# UNITED STATES PATENT AND TRADEMARK OFFICE

APPLICATION NO.	FILING DATE	FIRST NAMED INVENTOR	ATTORNEY DOCKET NO.	CONFIRMATION NO.
10/696,932	10/30/2003	James F. McGuckin JR.	1255	1044
<div>7590 NEIL D. GERSHON REX MEDICAL 1011 HIGH RIDGE RD Stamford, CT 06905</div>				
			<div>EXAMINER SHAFFER, RICHARD R</div>	
			<div>ART UNIT 3733</div>	<div>PAPER NUMBER</div>
			<div>MAIL DATE 11/20/2007</div>	<div>DELIVERY MODE PAPER</div>

## Office Action Summary

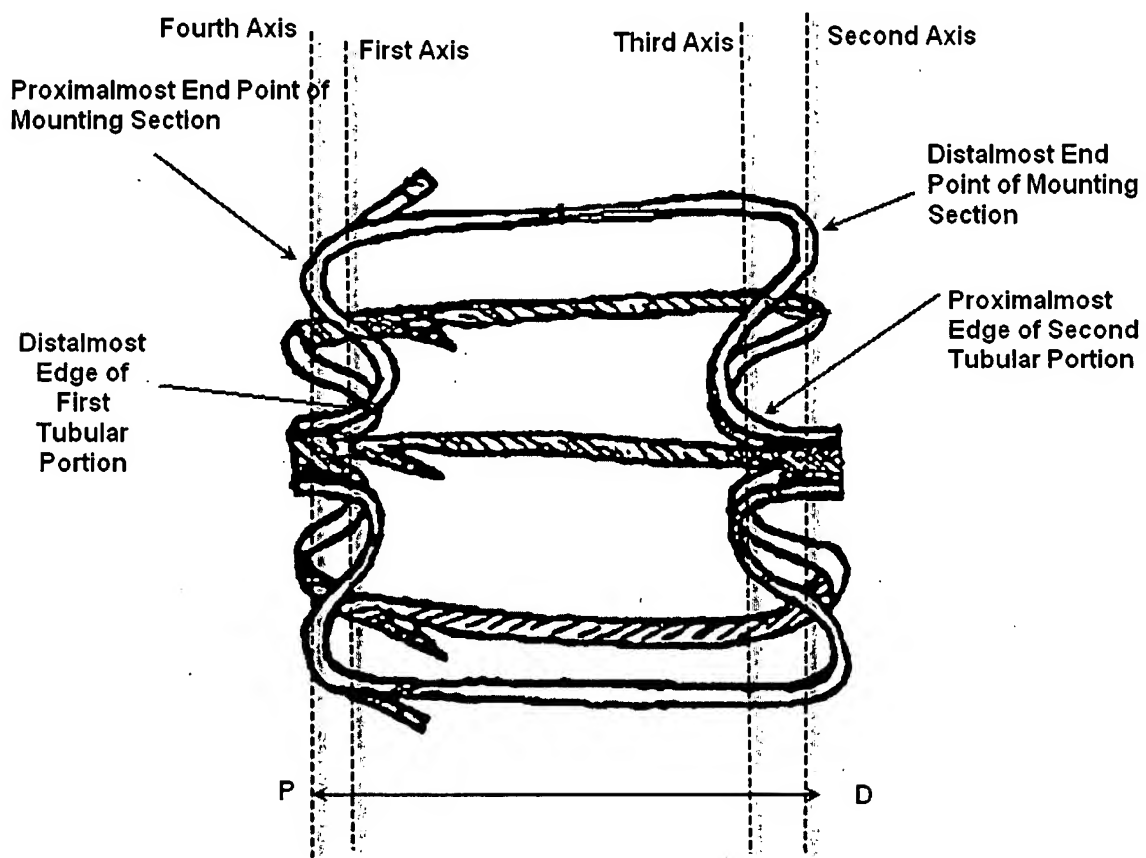
Bosma et al disclose all of the claimed limitations except for the specific structure and location of the filtering section with regard to the mounting section. van der Burg et al teach (**Figure 35; Column 18, Lines 34-55**) that an expandable device for placement against a bodily tubular structure with an S-shape end portion provides an elongated mounting section which improves contact area. It would have been obvious to one

having ordinary skill in the art at the time of invention to design the filter of Bosma et al according to the structure taught in van der Burg et al in order to improve fixation within the blood vessel. In regard to applicant's extensive claim language defining the relationship between the filter section and mounting section, see the Figure below depicting how the structure of van der Burg et al meets the claimed limitations.
